HL-5613

Edwin I. Hatch Nuclear Plant
Request for Additional Information on
Extended Power Uprate License Amendment Request

Edwin I. Hatch Nuclear Plant
Request for Additional Information on
Extended Power Uprate License Amendment Request

FIGURE 58-1

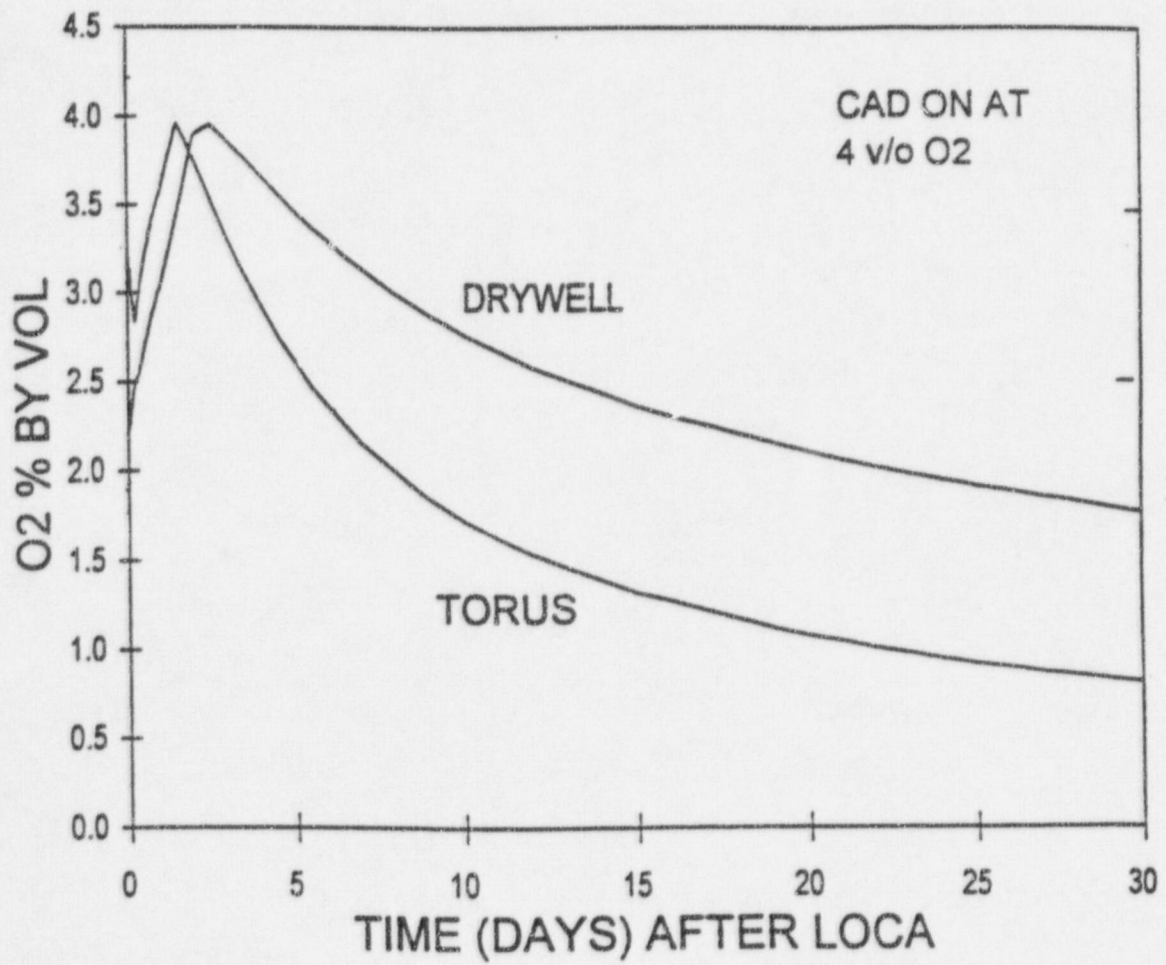
Enclosure 6, Section 4.5.2, indicated that the impact of an 8 percent increase in thermal power would cause the Unit 1 CAD System and Unit 2 recombiners to be initiated earlier. Provide the time responses.

The CAD system design for extended power uprate is also based on limiting the oxygen concentration inside the drywell and torus to a maximum of 4 vol %. The results of the revised analysis for extended power uprate indicate that an oxygen concentration of 4 vol % will be reached in about 1.55 days inside the torus and in about 2.14 days inside the drywell requiring the use of the CAD system. The CAD system will be started when the oxygen concentration reaches 4 vol %. As shown in Figure 58-1, with a constant CAD system nitrogen flow rate of 30 scfm each to the drywell and the torus, the oxygen concentration will be limited to 4 vol %. The total CAD system flow requirement of 60 scfm is well within the CAD system design capacity of 100 scfm.
